Question & Answer Matrix
July 7, 2026 - City Council Meeting

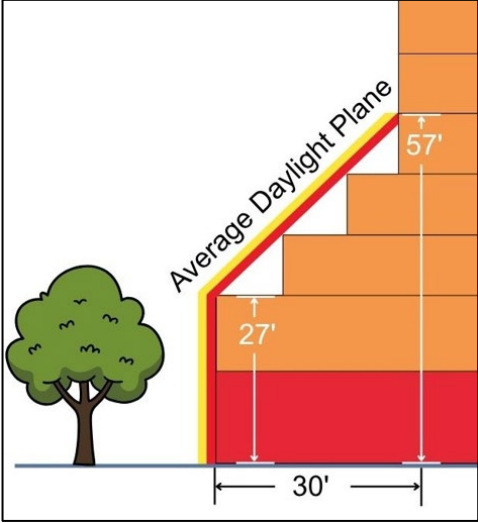
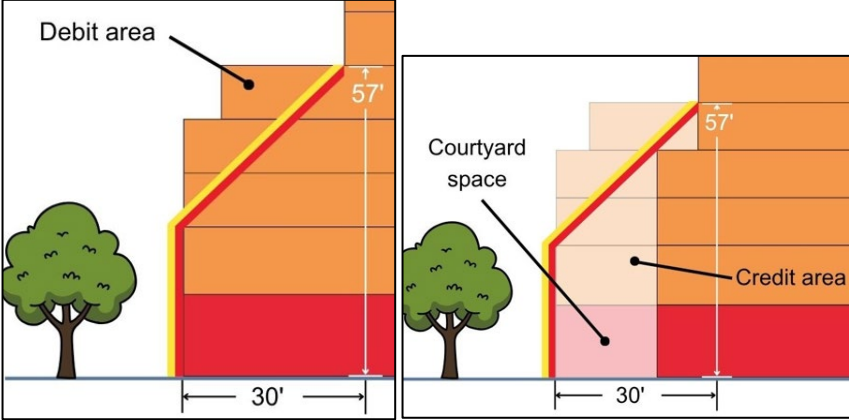
Log #	AB No.	Received From	Question	Staff Response
1	6962	Becker	Is there a redline of the Fee Schedule, or can you just confirm that there were no changes outside of section 8.C?	The only proposed change is to add the Affordable Housing Fee in Lieu of \$25 and the note that follows with explanatory text on how the fee is calculated (see AB6962x1 page 26, section 8.C in the Fee Schedule). We talked internally and will make sure that we include a redline of the changes to the Fee Schedule when it is presented to the City Council in the future.
2	6961	Becker	I’m confused about the Figure 6 Daylight Plane illustrations on Exhibit 1 pages 35-38. Specifically, the measurement for the 30’ step back in the illustrations do not line up with the building at the upper floors. In the illustration, the building appears to be ~26’ from the property line, should those be 30’ too? Is this a quirk of the drawing or am I misunderstanding how this works?	The illustrations in Figure 6 correctly depicts the daylight plane requirements in the code. There are three key dimensions for the daylight plane illustrations in MICC 19.11.030- Figure 6 (Ord. No. 26C-10, Exhibit C): • 27 Feet – the vertical height at which the upper-story step back must begin. This is approximately the upper extent of the second story. • 30 feet – the horizontal depth of the upper-story step back, measured from the edge of the sidewalk. This is roughly the depth at the fifth story if a forty-five-degree line is drawn from the upper extend of the second story, where the step back begins. • 57 feet – the point at which the upper-story step back stops. Portions of the building taller than this point do not have to be stepped back more than 30 feet from the edge of the sidewalk.

Log #	AB No.	Received From	Question	Staff Response
				Excerpt from Figure 6: A diagram showing a stepped building facade. A yellow line labeled 'Average Daylight Plane' runs diagonally across the steps. The building is divided into a red base and orange upper sections. A tree is to the left. Dimensions: 30' width at the base, 27' height for the red base, and 57' height for the orange section above the base line. Effectively, this defines a trapezoid in which building facades may either conform to the upper-story step back or average the areas that protrude beyond the plane (debit area) with the areas that are set back from the plane (credit area) so that the average conforms to the trapezoid. The debits and credits are measured in cubic feet, and credit areas must equal the debit areas.

Log #	AB No.	Received From	Question	Staff Response
				Excerpts from Figure 6:  Note: this is not the only building facade modulation requirements in the Town Center. MICC 19.11.100 - Building Design also requires building facades to be modulated with a variety of architectural elements.
